Access Compliance Report

Public Rights-of-Way

(Curb Ramps)

Intersection ID: 53224	Main Street: URBAN_PL	Cross Street: GIVENS_WY	Location: SW
ADA ID: 7BFDF7885CFB	Ramp Type: BlendTrans1	Initial Pass/Fail: Fail	Overall Compliance: No
		Severity Score: 8.75

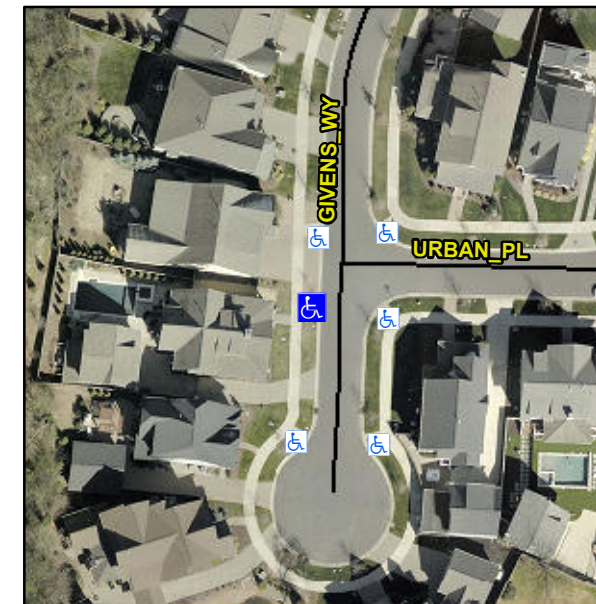
Not Found, R304.5.1

Compliance	Description	Data	Compliance	Description	Data
N/A	Ramp Length (in)	95.5	Yes	BlendTrans Slope (%)	4.0
No	Ramp Width (in)	39.5	Yes	BlendTrans XSlope (%)	1.3
N/A	Flare Type LT	N/A	N/A	Flare Type RT	N/A
N/A	Flare Slope LT (%)	N/A	N/A	Flare Slope RT (%)	N/A
N/A	Flare Traversable LT?	N/A	N/A	Flare Traversable RT?	N/A
N/A	Landing Length (in)	N/A	N/A	DWS Provided?	N/A
N/A	Landing Width (in)	N/A	N/A	DWS Contrast?	N/A
N/A	Landing Slope (%)	N/A	N/A	DWS Length (in)	N/A
N/A	Landing X Slope (%)	N/A	N/A	DWS Full Width?	N/A
N/A	Landing Curb? (Y/N)	N/A	N/A	DWS Offset (in)	N/A
N/A	Shared Landing?	N/A			
N/A	Gutter Ponding?	N/A	N/A	Gutter Slope (%)	N/A
N/A	Gutter Lip Ht (in)	N/A	N/A	Gutter X Slope (%)	N/A
N/A	Painted X Walk1?	No	N/A	Painted X Walk2?	N/A
	X Walk 1 Direction	To E		X Walk 2 Direction	N/A
	X Walk 1 Width (in)	N/A		X Walk 2 Width (in)	N/A
	X Walk 1 Slope (%)	2.1		X Walk 2 Slope (%)	N/A
	X Walk 1 X Slope (%)	1.1		X Walk 2 X Slope (%)	N/A

N/A	Ramp inside XWalk1?	N/A	N/A	Ramp inside XWalk2?	N/A
	Road Slope (%)	1.1		Clear Space?	N/A
	Road X Slope (%)	2.1	N/A	Clear Space to XWalk (in)	N/A
N/A	Any Obstructions?	N/A	N/A	Storm Grate/Utility Hazard?	N/A
	Obstruction Type			Storm Grate/Utility Type	
		N/A			N/A
			Yes	Surface Condition? (G/P)	Good
			No	Curb Slope (%)	11.7

Remove & Replace Curb Ramp With Two New Directional Ramps or Equivalent.
